Title:	Improved Slide Design for Schlage ND-Series
Date:	October 2009
Product:	Schlage ND-Series
Viewers:	ALL

Improve Slide Details

*New ND Slide
Part # N523-149*

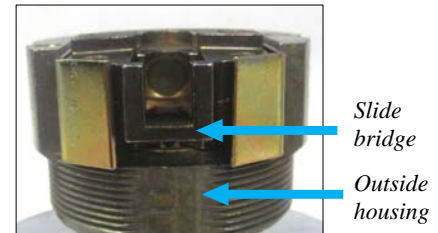
The new slide part number is **N523-149**. There is no change to the slide part price. This is a running change and does not impact the use of existing slides (N523-024) in inventory or in installed locks.

- **The bridge** – The bridge closes the gap on one side of the slide and serves to reinforce the slide and prevent the latch plunger bar from “fish-tailing” and interfering with the keycam ears.
- **Improved slide spring seat** – The new slide has tighter dimensions designed to better hold the slide springs into place, making it easier to re-assemble the slide and slide springs when servicing the chassis or changing functions.

ND Chassis Assembly – Side View

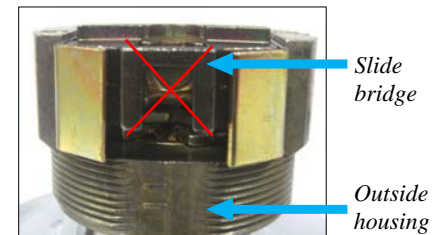
- With the addition of the bridge, the slide is no longer symmetrical. If you are re-assembling the chassis, please note the slide should be assembled so the bridge is on the same side as the keycam, outside housing, and the exterior side of the lock to allow the chassis assembly to allow engagement with the latch plunger bars.
- For additional reinforcement and to ensure proper installation of any ND lock installed on hollow metal doors, Schlage recommends using the metal door reinforcer kit (part # 37-001). The reinforcer centers the latch in the door and reinforces against latch movement to prevent binding issues.

CORRECT - The slide's bridge is assembled facing the direction of the outside housing and keycam.

INCORRECT - The slide's bridge is assembled facing away from the outside housing and keycam, which will block engagement with the latch.
